Re: Request for Time Extension – New Construction of a Single-Family Home
Located at Approximately 757 N. Wall Street
Petitions PLNHLC2014-00628 & 00730

Re: Petitions PLNHLC2014-000730 & PLNHLC2014-00628
New Single-Family Home at approximately 757 N. Wall Street

New Single Family Dwelling New Construction PLNHLC2014-00730 and PLNHLC2014-00628 757 North Wall Street

Previous Site Plan

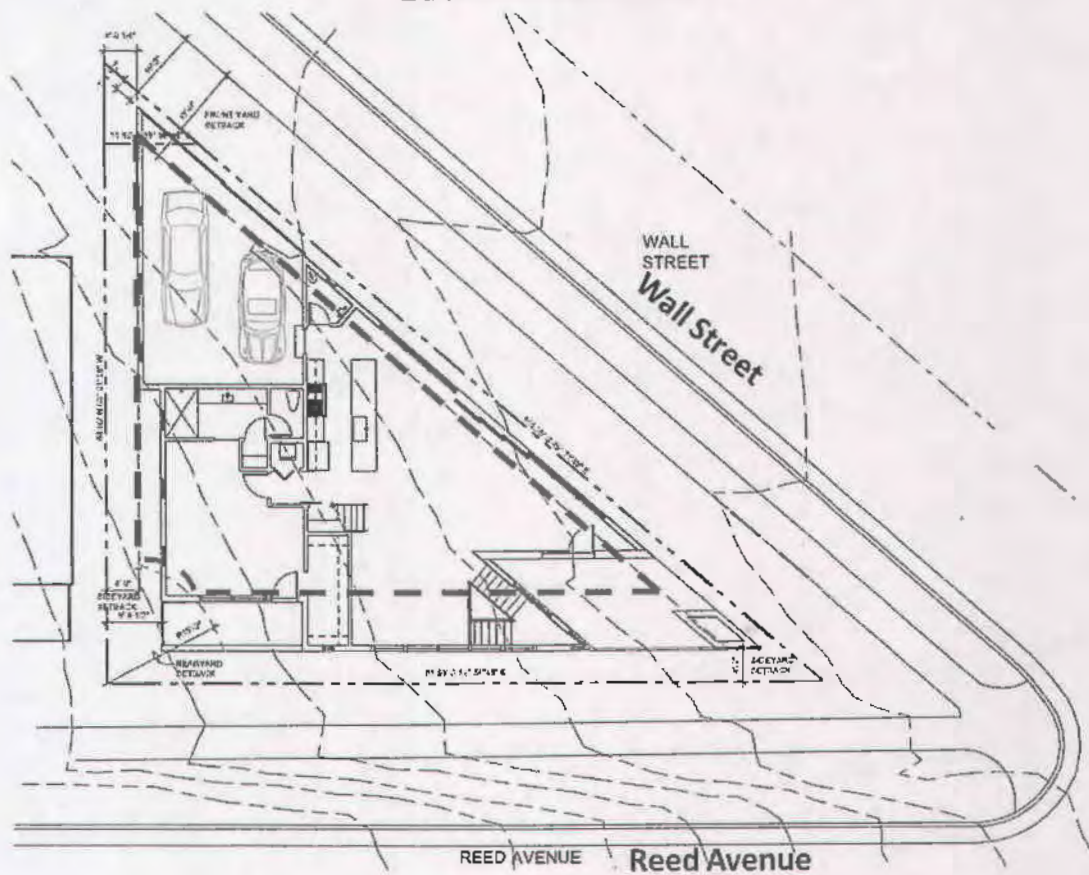
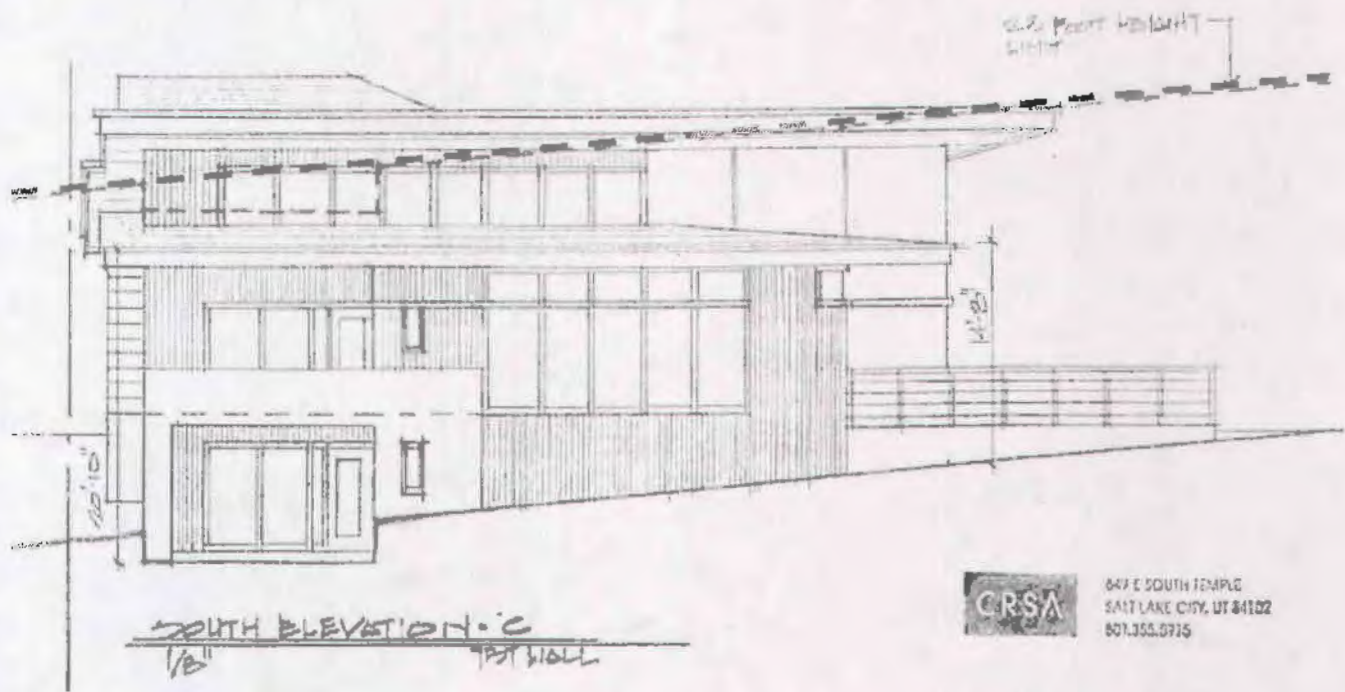
1. The proposed residence is out of scale with the neighborhood; it's too large.

2. The proposed residence is in excess of the maximum lot coverage.

Applicant response - Due to the allowance of tandem parking, we were able to reduce the footprint of the home from approximately 2,300 square feet to 1,438 square feet and still provide the required 2-car parking: the garage is approximately 327 square feet for a total footprint of 1,765 square feet, a 23% reduction.

Applicant response - The new design represents a 10% reduction in lot coverage. If we calculate the area of the lot sidewalk to sidewalk, the lot coverage drops from 45% to under the 40% maximum requirement at 35% lot coverage. However, due to the unusual property lines, we are still requesting an exception for lot coverage, which is now 53% calculated by actual lot size (down from 63%).

Previous South Elevation Showing 23 Foot Height Standard

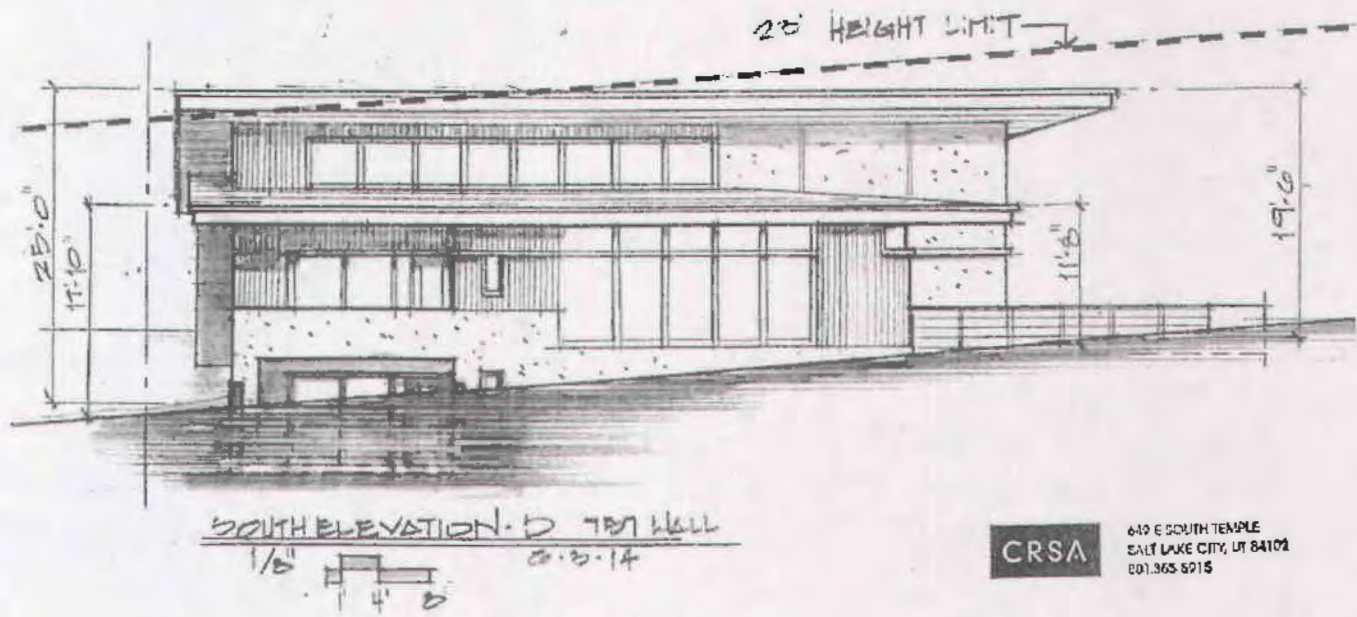
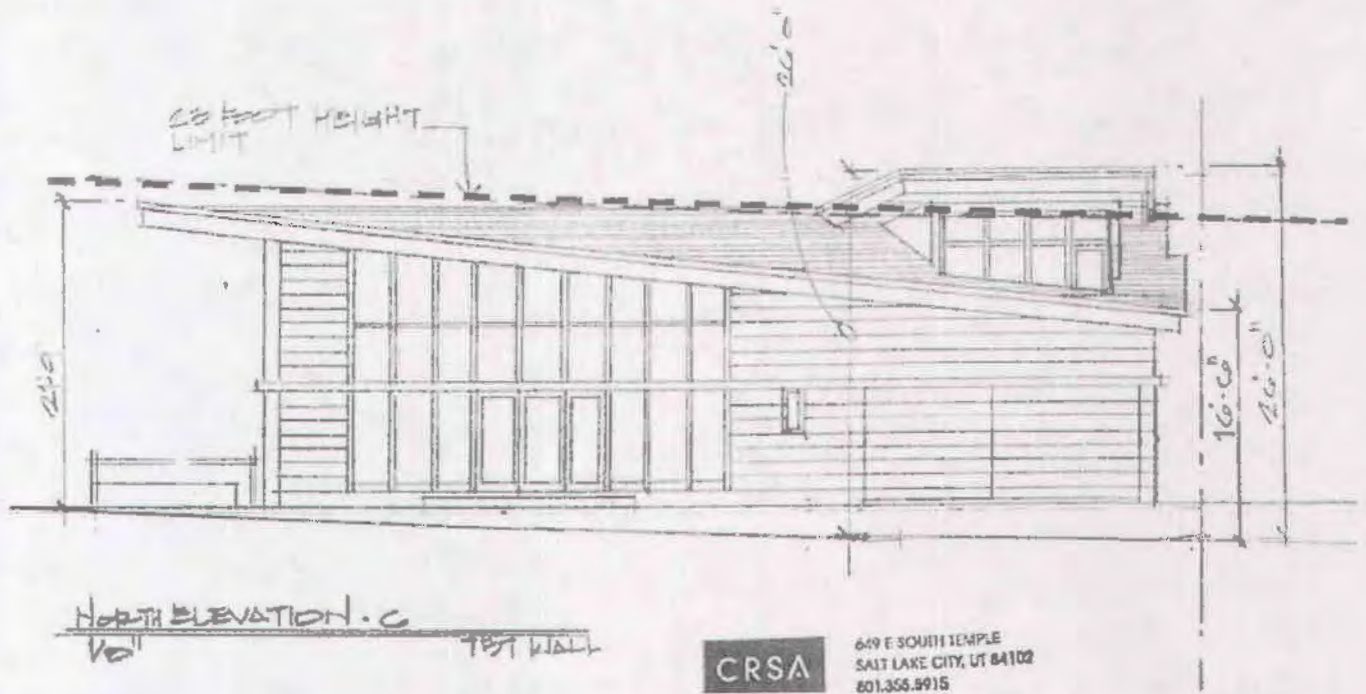
5. The proposed residence is too tall.

CS: The proposed home has a long eave line at maximum height. It is a large roof compared to other roofs on the Reed Avenue block face.

Applicant response - Due to the new garage design, we have eliminated the need for a height exception, as the home no longer extends into the southwest corner of the lot.

Previous North Elevation Showing 23 Foot Height Standard

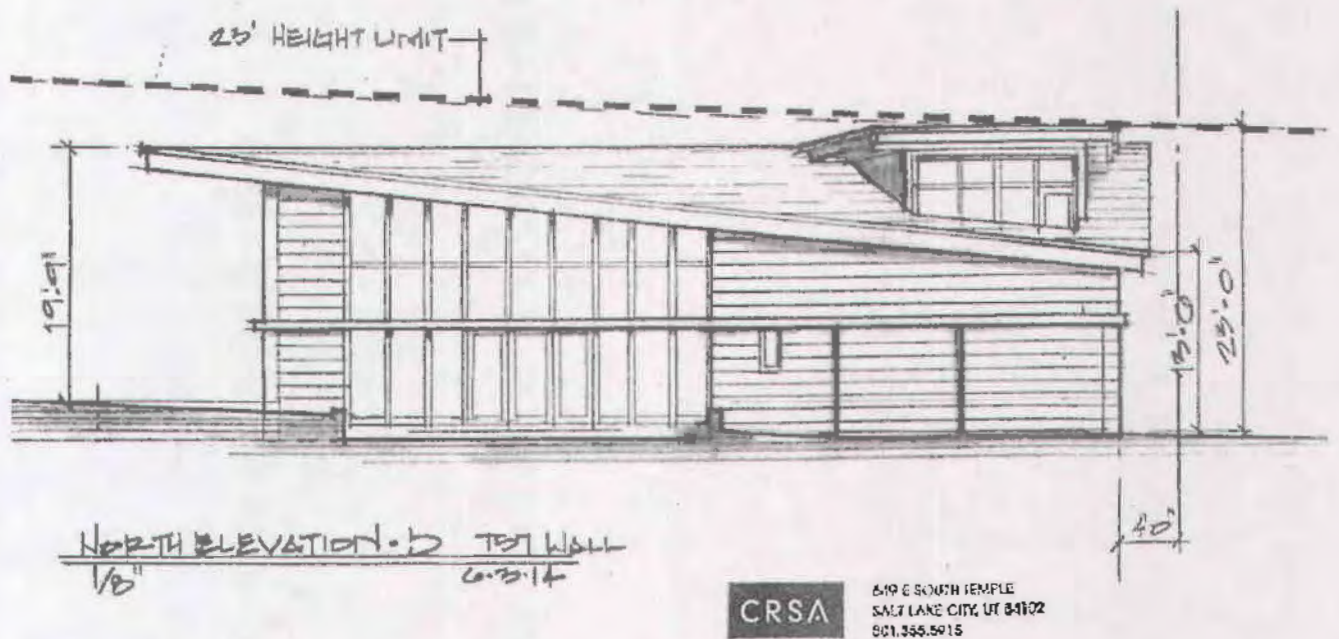
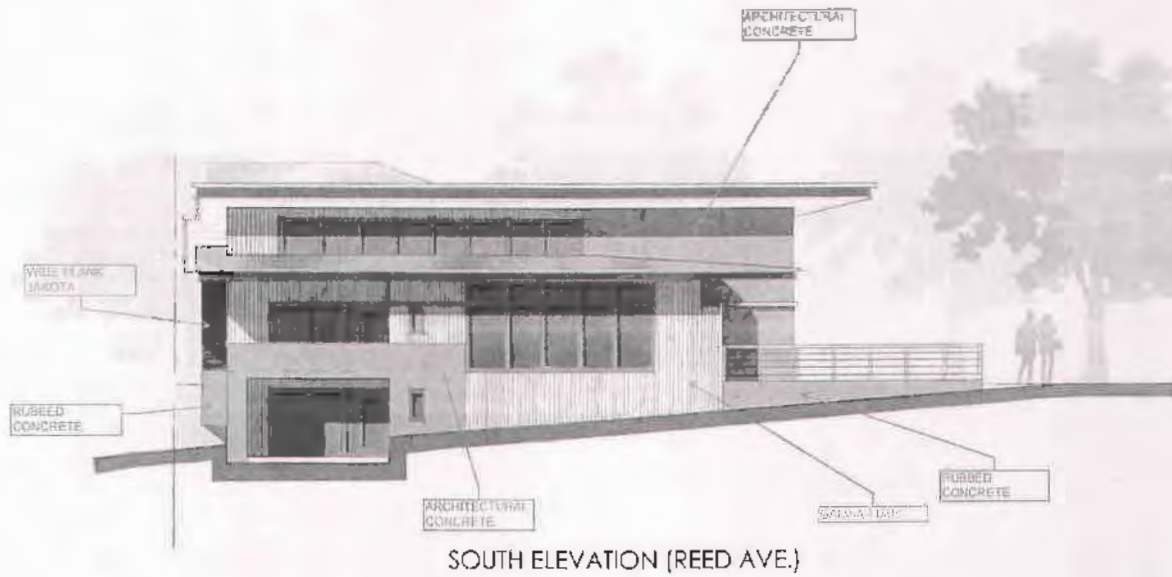
4. Shorten the total length of the facade along Wall Street.

- If the wall of glass was modified it would be approvable, mass along Wall Street was a fairly large flat wall, other than lowering the building, it hadn't changed from the previous proposal.

Applicant response - By eliminating the attached 2-car garage, we were able to shorten the overall length of the home on Wall Street by over 20 feet. In addition, the enclosed garage is set back from the sidewalk by 25-30 feet, which greatly softens the facade along Wall Street. Our re-design initially proposed a detached garage. However, the garage has been attached to the home, allowing for the required 4' side yard set-back. The garage/west wall is a full 10' from the neighboring home.
